# TOWN OF PARADISE VALLEY

Discussion of Statement of Direction  
Andaz Resort Intermediate Special Use Permit Amendment  
6160 N Scottsdale Rd & 6041 N Quail Run Rd  
Town Council  
Work Study

September 8, 2022

# GUEST UNIT POOLS & FENCE WALLS

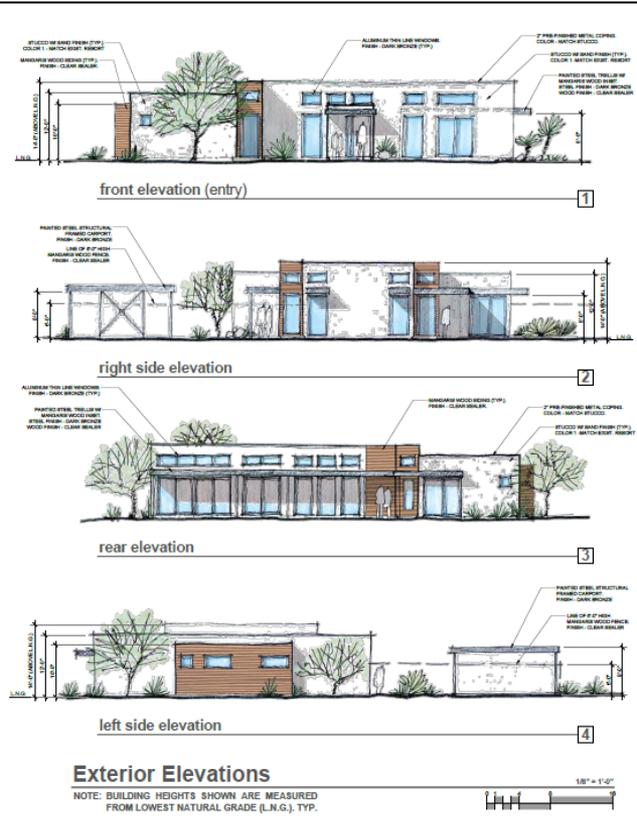
- b. SUP Guidelines recommended fences meet residential fence walls standards in Article 24 of ZO. Western fence wall and portions of internal "yard" walls adjoining Quail Run Rd not compliant with standards in Article 24; which identifies 6' tall meandering fence wall shall meander between 10' and 20' setback lines with average setback of 15'. Proposed fence has slight meander with much of fence on the western property line (0' setback) and portions of wall setback 6' to 14' from property line. Also, many internal yard walls connect to perimeter fence at western property line.

## DRAFT SOD – SIGNAGE

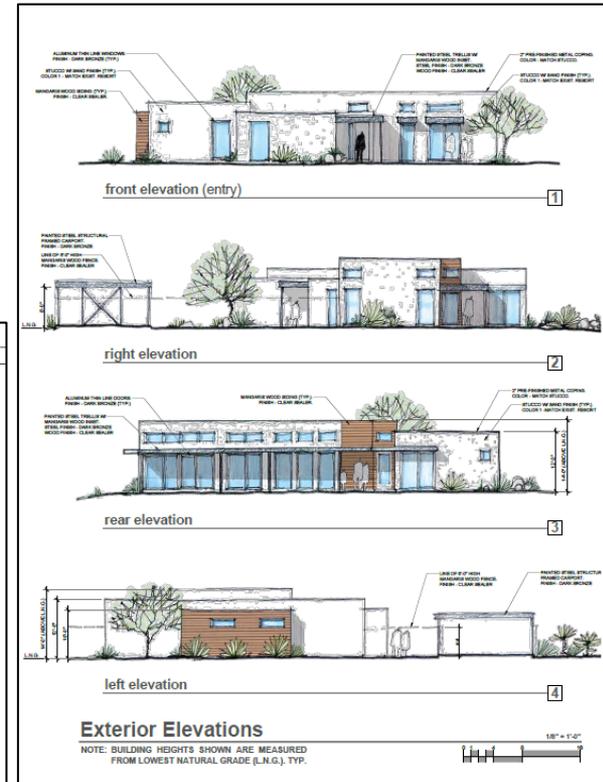
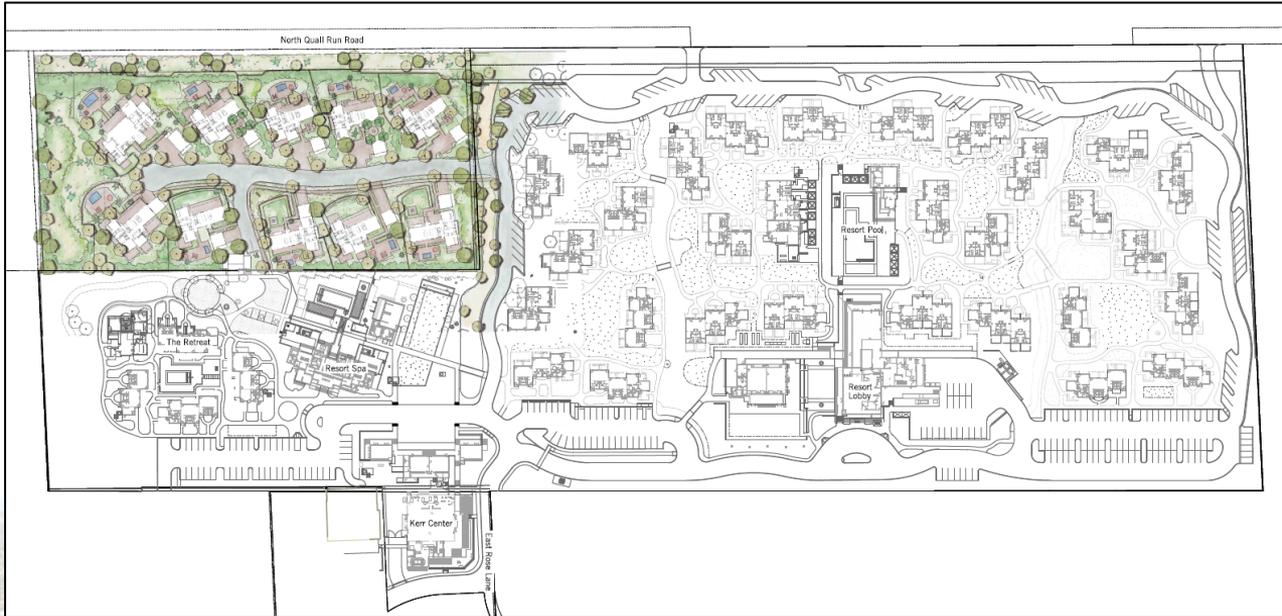
7. New building and directional signage will accommodate improvements. SUP Guidelines identify recommended standards for monument and directional signs, but do not provide recommended standards for building signage. Commission shall evaluate the size, height, location, and illumination of all proposed signs for appropriateness with SUP and compliance with SUP Guidelines.

# G&D PLAN

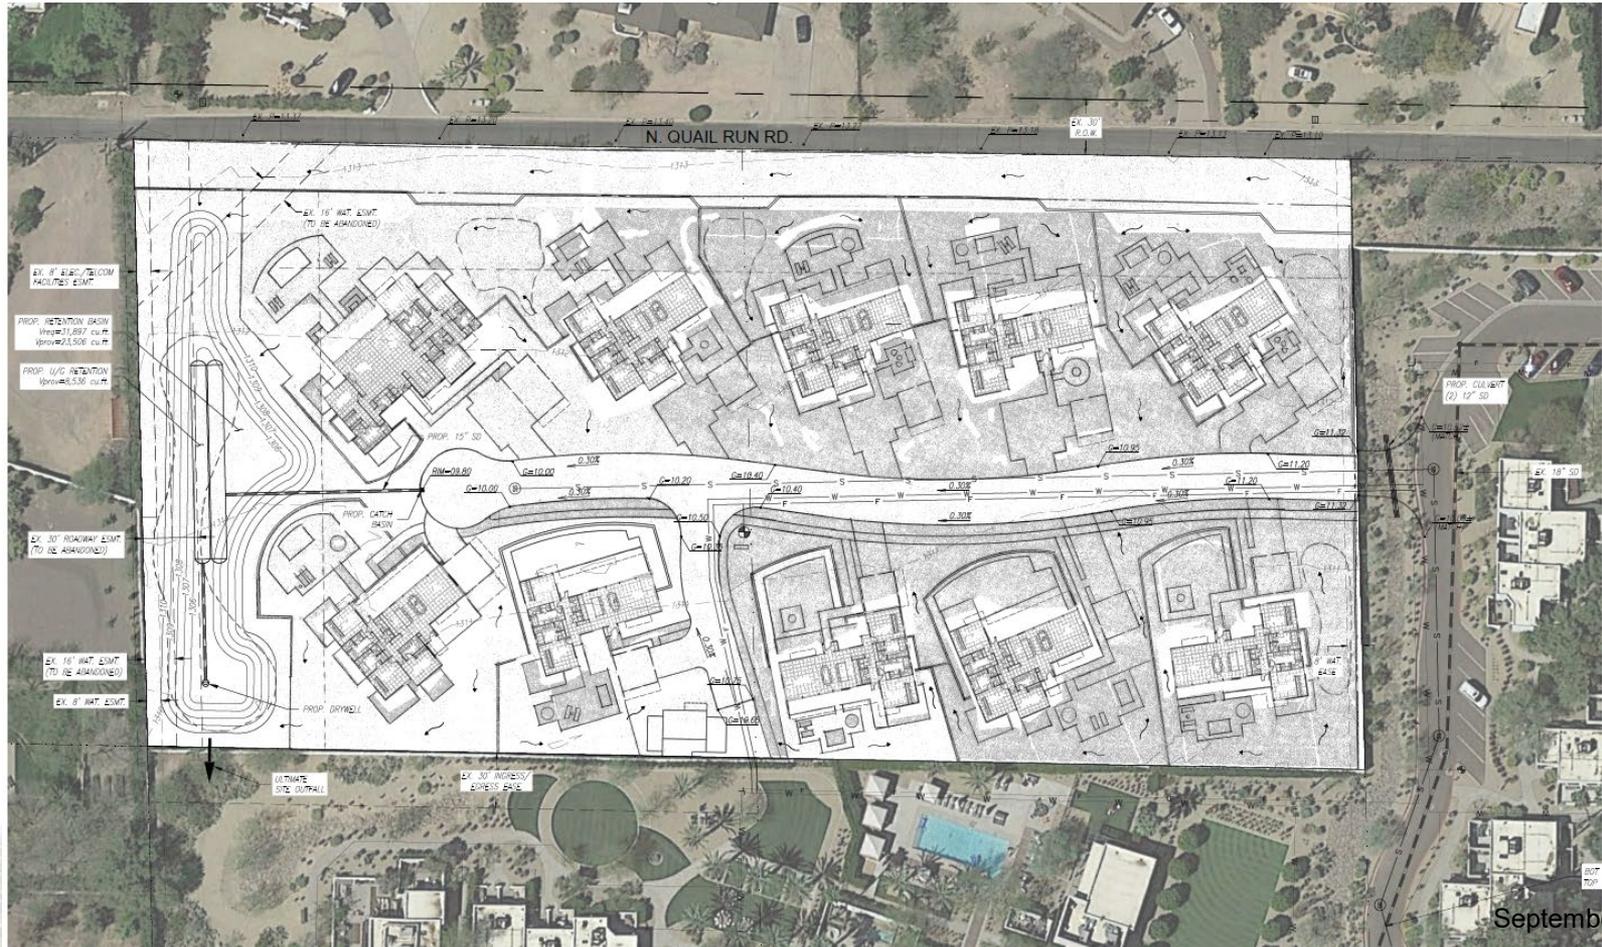
5. Conceptual G&D plans and preliminary drainage memo, water system analysis, and sewer system analysis have been provided.

More detailed plans and reports shall be provided for PC review and evaluation. Commission shall review and examine storm water flows, on-site retention, location of utility cabinets and pedestals, preliminary sewer plans, preliminary water basis of design report, and fire flow rate for this area.
